ADDENDUM #4

Rye City School District

Issued: 2021-02-17

SEAL & SIGNATURE DATE: 02/12/20
PROJECT No: 9200
DRAWING BY: Author
CHK BY: Checker
DWG No:
A2-120

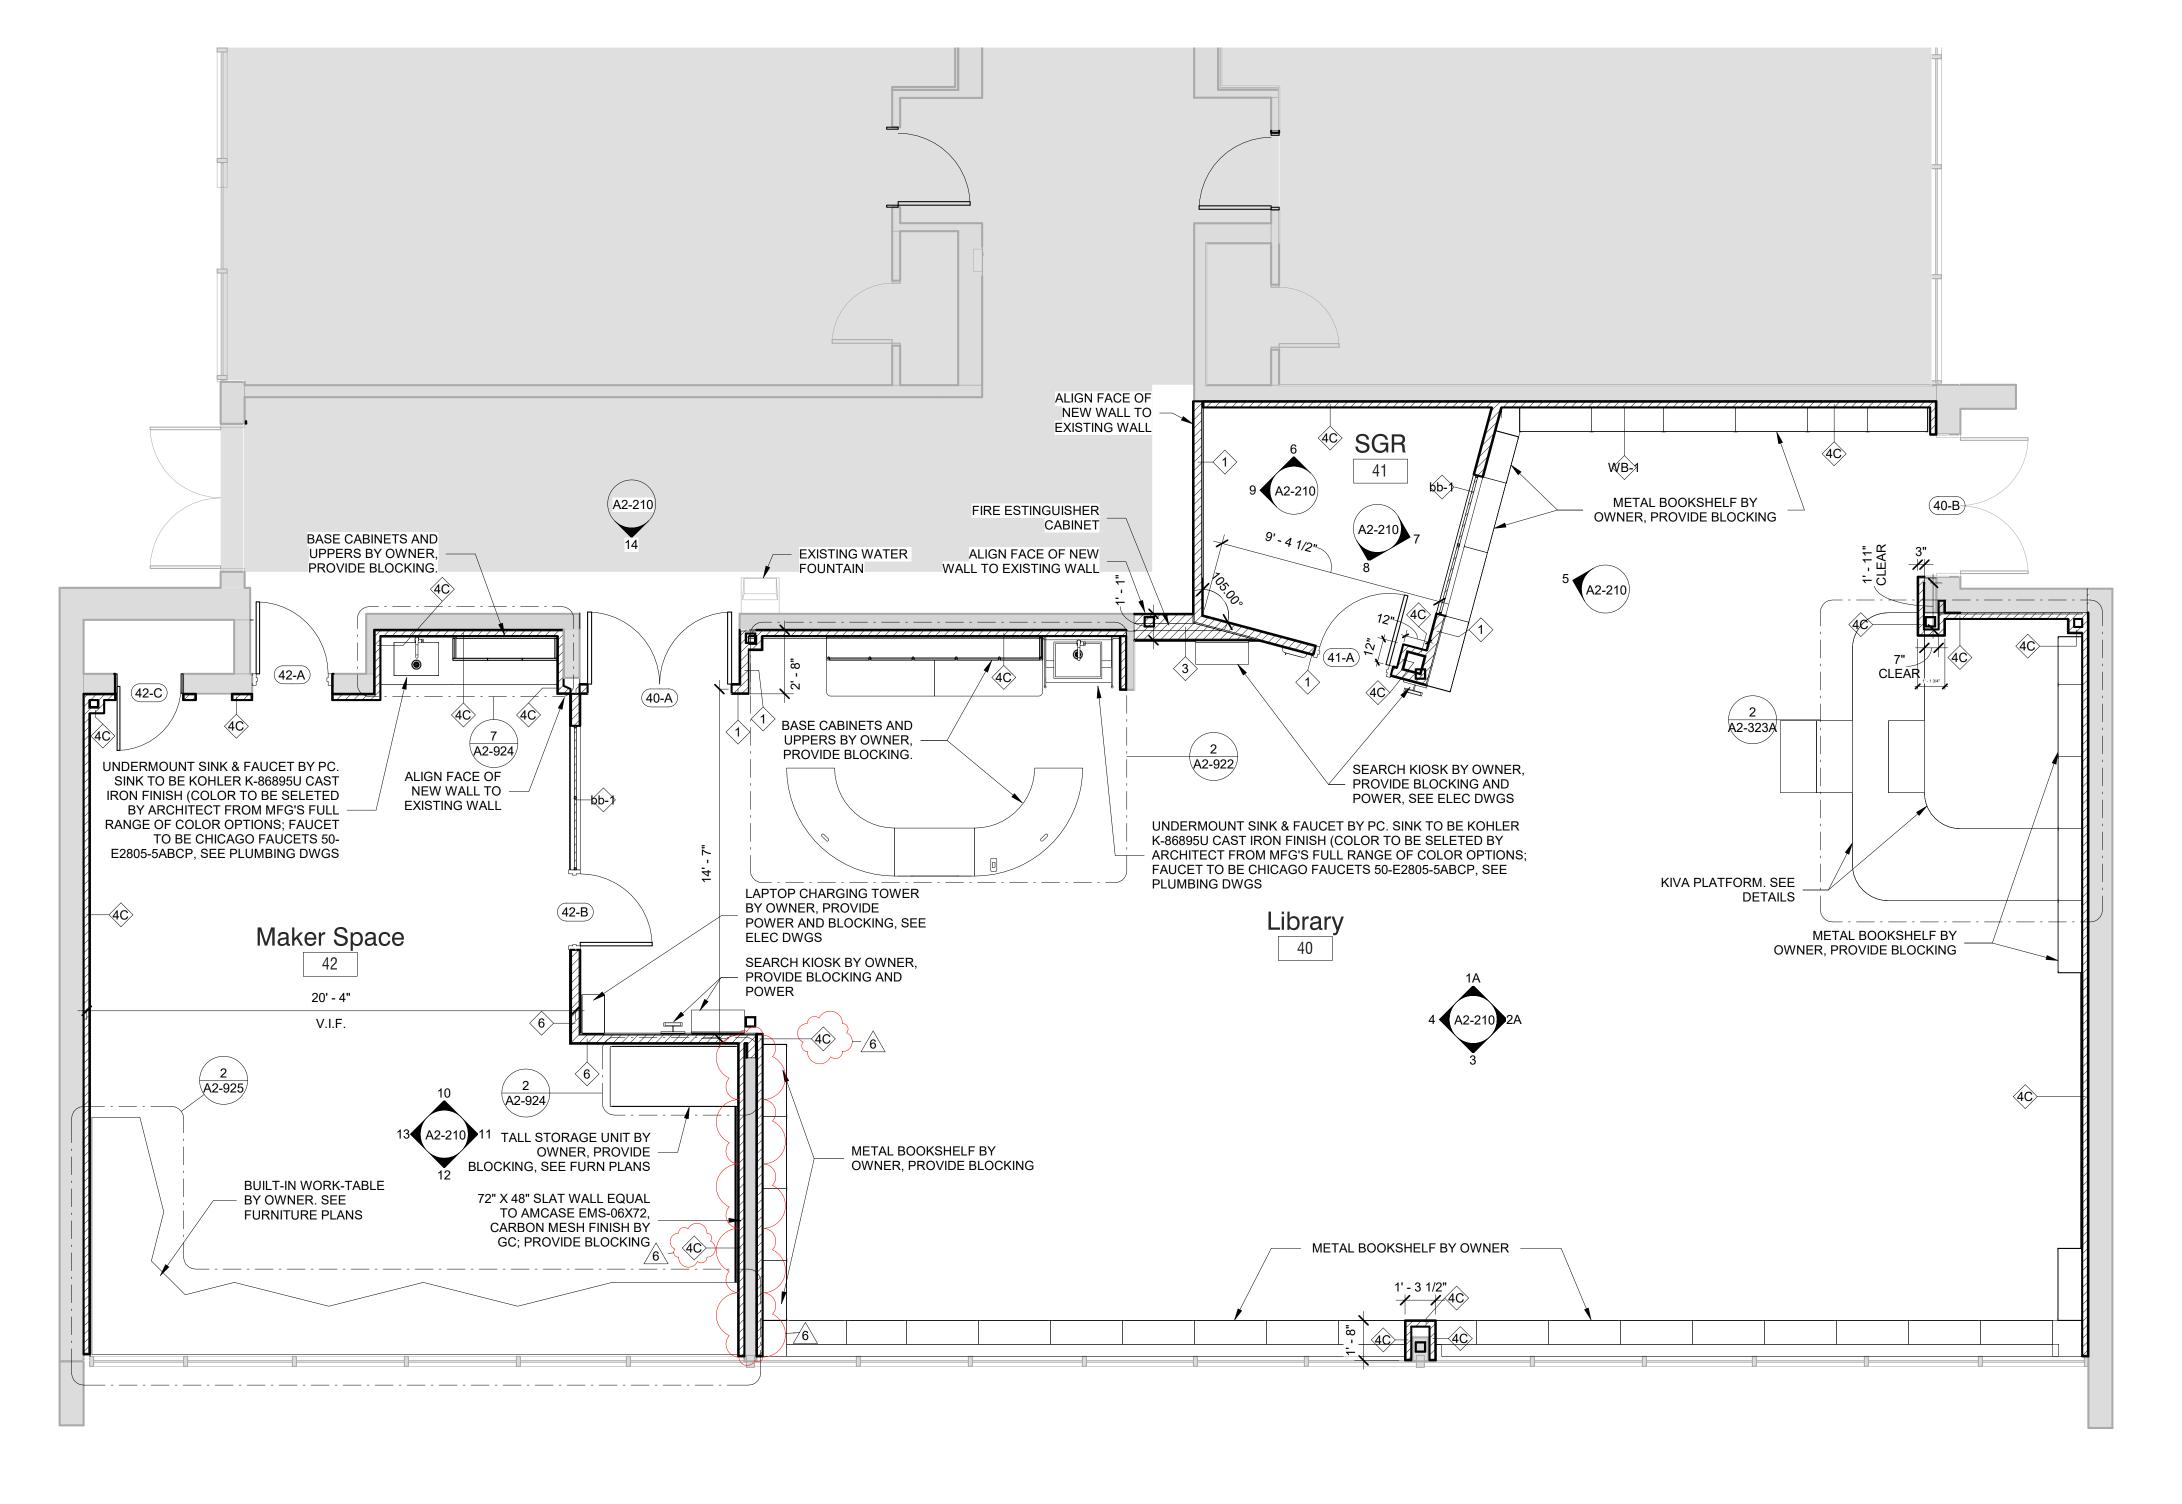
- 1. A2-120 and A2-120A:
 - a. Furring walls added at existing wall.
- 2. A2-121 and A2-121A:
 - a. Data locations added.
- 3. A2-601:
 - a. Door 15 frame type updated.
 - b. Door E-15 door type updated.
 - c. Door schedule updated to show galvanized steel framing for 45min rated systems.
 - d. Door schedule updated to show hollow metal doors and frames.
- 4. A2-607:
 - a. Note added for location of ballistic rated metal infill panel to drawing 1/A2-607.
- 5. A2-700:
 - a. Vinyl wallcoverings to be by GC. Finish legend updated to reflect this.
- 6. A2-730:
 - a. GC to contact architect to receive high-resolution image files of wallcovering designs prior to ordering. Notes added to reflect this.

SEAL & SIGNATURE DATE: 02/06/20
PROJECT No: 9200
DRAWING BY: Author
CHK BY: Checker
DWG No:
A2-120

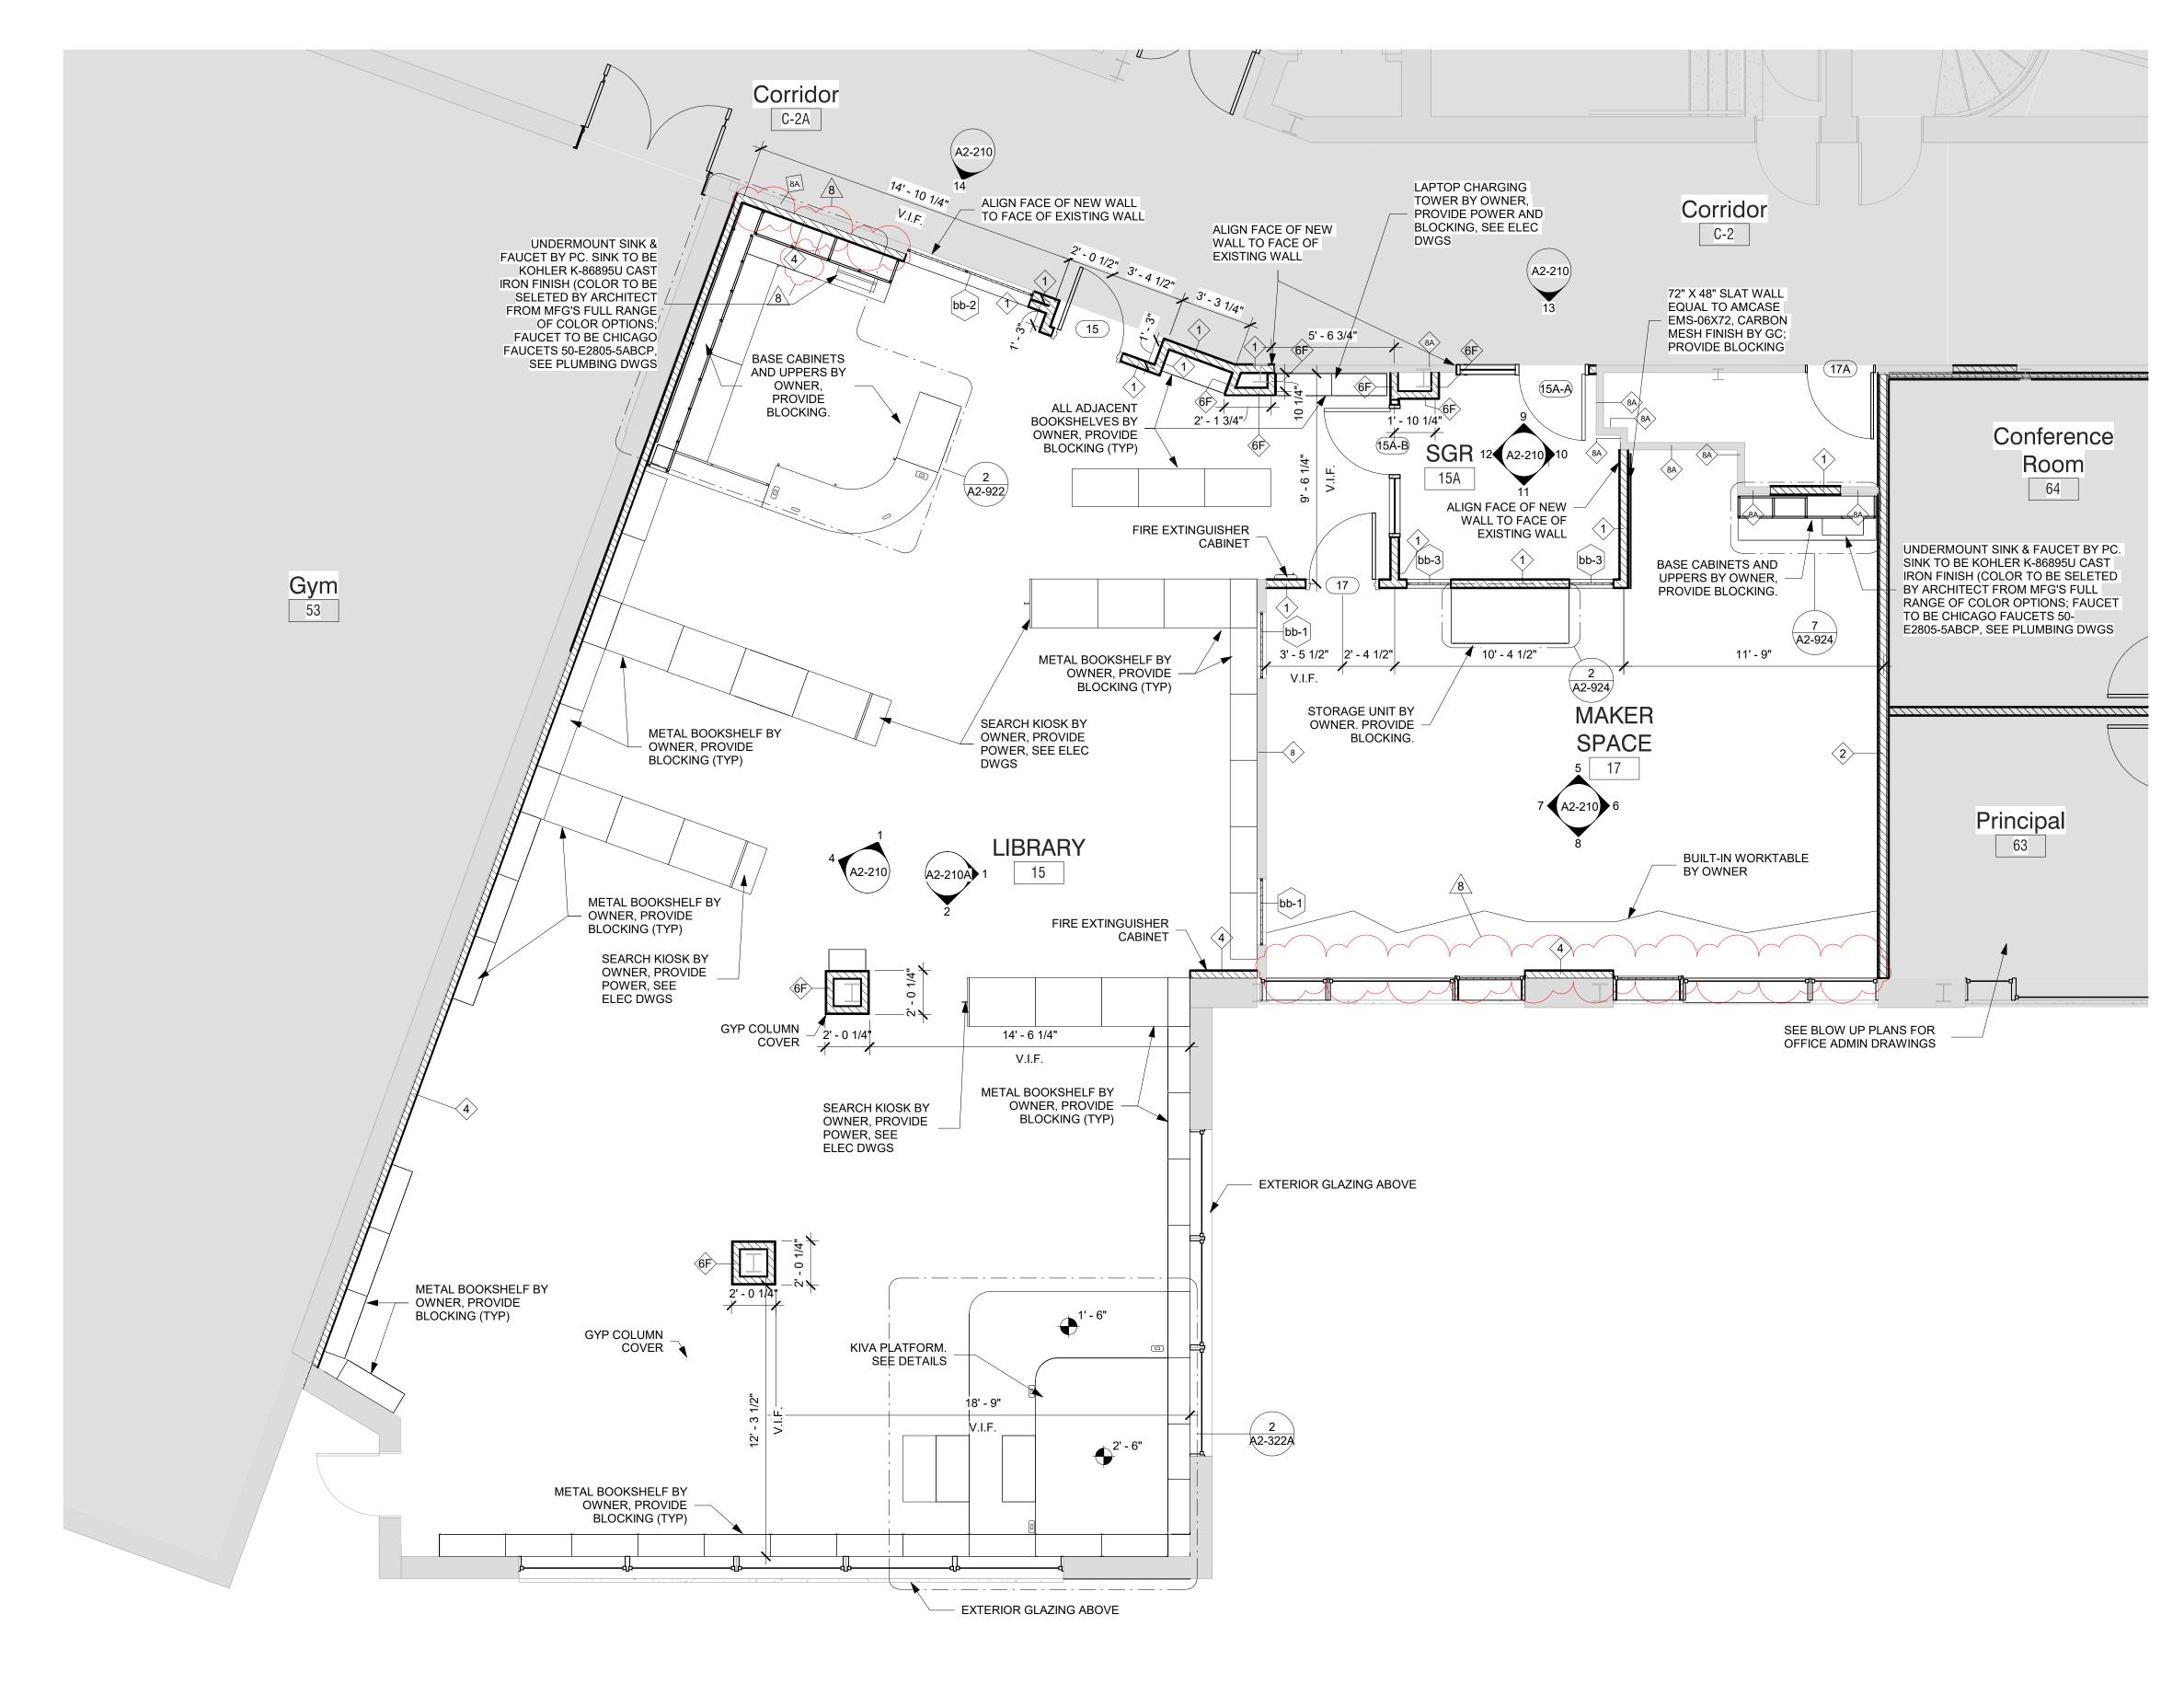
- 1. A2-120 and A2-120A:
 - a. Furring walls added at existing walls as shown.
- 2. A2-121 and A2-121A:
 - a. Data locations added.
- 3. A2-202:
 - a. Window types updated at drawings 4 & 5/A2-202.
- 4. A2-601:
 - a. Door schedule updated to show galvanized steel framing for 45min rated systems.
 - b. Door schedule updated to show hollow metal doors and frames.
- 5. A2-602:
 - a. Door types D-15A and D16 updated.
- 6. A2-700:
 - a. Vinyl wallcoverings to be by GC. Finish legend updated to reflect this.
- 7. A2-730:
 - a. GC to contact architect to receive high-resolution image files of wallcovering designs prior to ordering. Notes added to reflect this.
